FMC920 Product Change Notifications

Product change notifications (PCN) is the way of informing customers of upcoming changes related to Teltonika products. This includes outward appearance adjustments, hardware improvements, firmware changes, changes to package contents, etc. This page stores information regarding changes to the FMC920 tracking device. Below you will find a list of both upcoming and already implemented changes sorted from newest to oldest (top to bottom).

2023.11.13: Top Laser Printing Changes

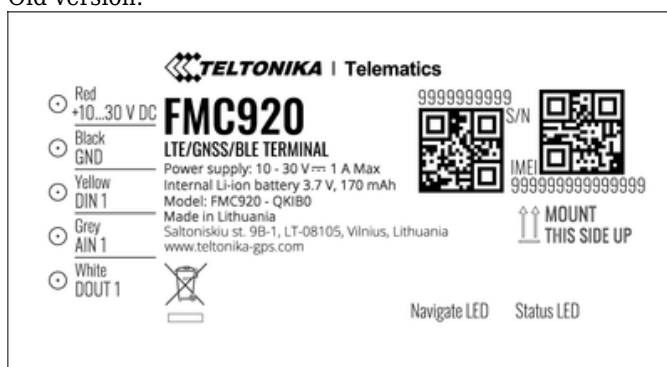
We would like to inform you, that laser printing of the FMC920-QKIB0 device will updated in the factory starting from December 15th 2023.

Change type External/visual
Top laser printing design changed
Old version:

New version:
[400px](#)

Change reasons 1. Added Anatel certificate number.
2. Added Bluetooth® SIG label.
